**FEDERAL HIGHWAY ADMINISTRATION
FINDING OF NO SIGNIFICANT IMPACT (FONSI)**

Interstate 90 Exit 406 Interchange
Brandon, South Dakota

APPENDIX A – Public Comments and Responses

Figure 2. I-90 Exit 406 Interchange Proposed Action

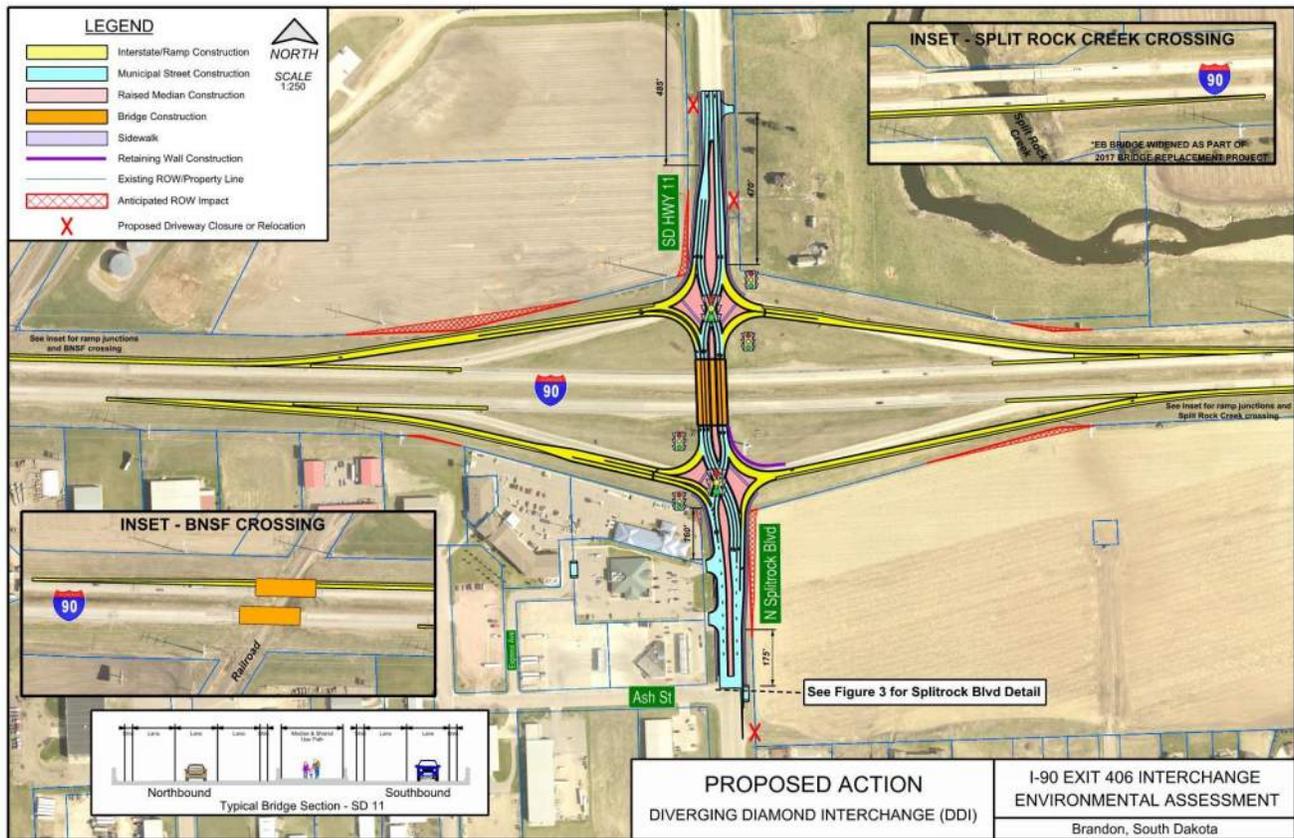
- I. Verbal questions and comments received during the Open House.
 - Several questions were received regarding the operations of a Diverging Diamond Interchange (DDI).

- Comments about the right turn from eastbound I-90 exit ramp to southbound SD11 noted concerns about safety at this location; and interest in how right turns will be handled on the new interchange.

- Will the wind towers that are shipped out from Marmen be able to maneuver through the interchange?
 - One of the advantages of this interchange configuration is that it can accommodate long truck-trailer combinations like those with wind towers. As described in the EA, one of the factors that caused the elimination of roundabouts from the project corridor was the ability to accommodate large trucks.

- Responses varied depending on the nature of the question. However, the noteworthy advantage of a DDI interchange configuration is the provision of safer and more efficient left turning movements (such as the northbound SD11 turn on to westbound I-90).

- The turn noted has been identified in the project study as a safety concern due to operational and crash history. With the DDI configuration, a signal specific to that turning movement will be installed to control the intersection.

Figure 3. Splitrock Boulevard Proposed Action

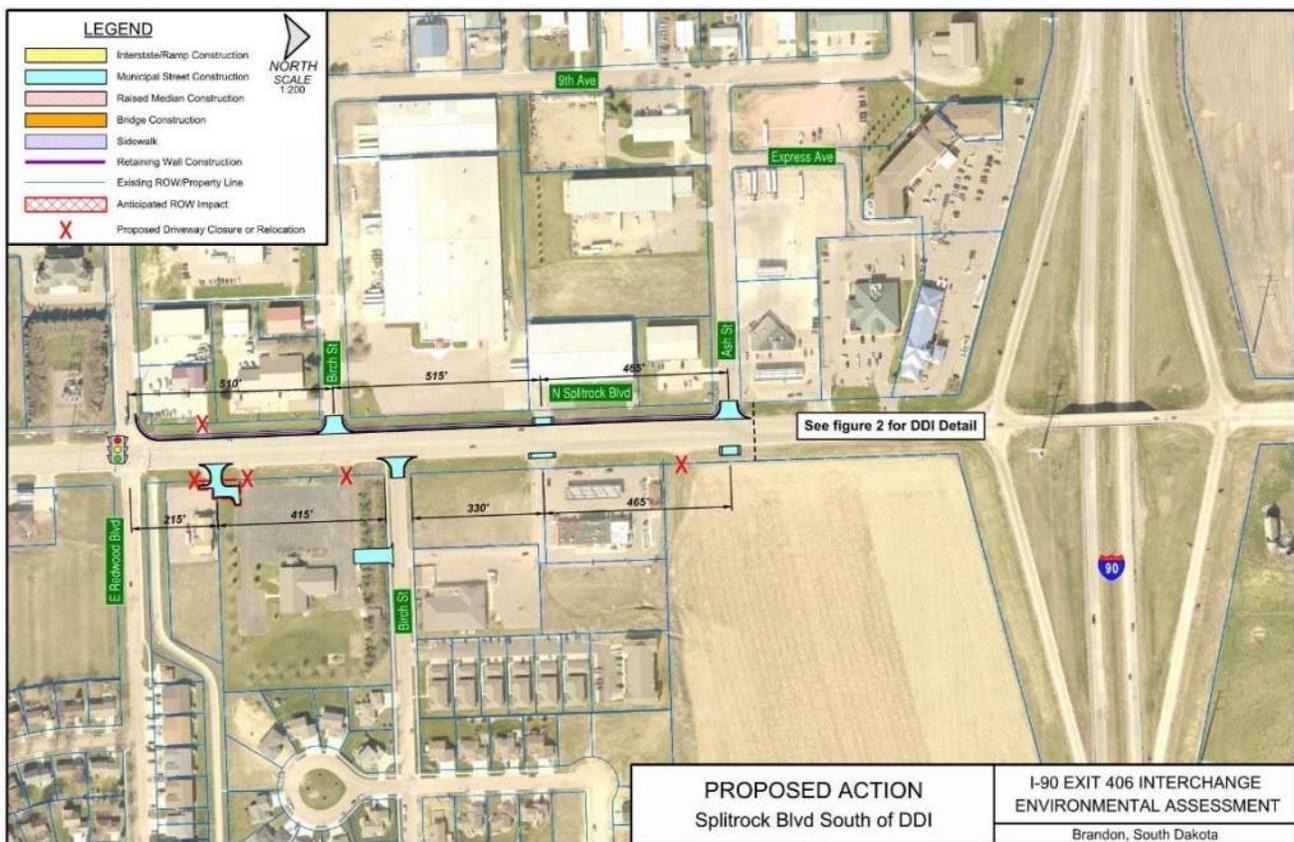
- How will the gas station and restaurant between the interchange ramp and Ash Street be accessed?
 - They will have right-in/right-out access for southbound SD11 traffic. Vehicles coming from northbound SD11 will likely access these business by turning on to Ash Street and then, if necessary, taking Express Avenue to arrive at access to these properties.

- Why is there a raised median on Ash Street?
 - The median (located north of Ash Street) is a necessary component of the DDI interchange in order for it to operate as intended.

- The owner of Tailgators noted the need for breaks in the SD11 median in order to allow left turns from northbound SD11 into his property. The closure of this access appears unwarranted for the majority of the day.

- A resident asked whether southbound traffic on SD11 would be permitted to make a U-Turn at the Ash Street intersection.
 - Current city ordinances allow for a U-Turn at unsignalized intersections. The Proposed Action does not include a signal at Ash Street; therefore a U-Turn would be permitted.

- The median is considered a fundamental feature in the design and operation of a DDI. Breaks in the median would risk continued safety concerns and failure of the interchange to operate in the manner intended by SDDOT.
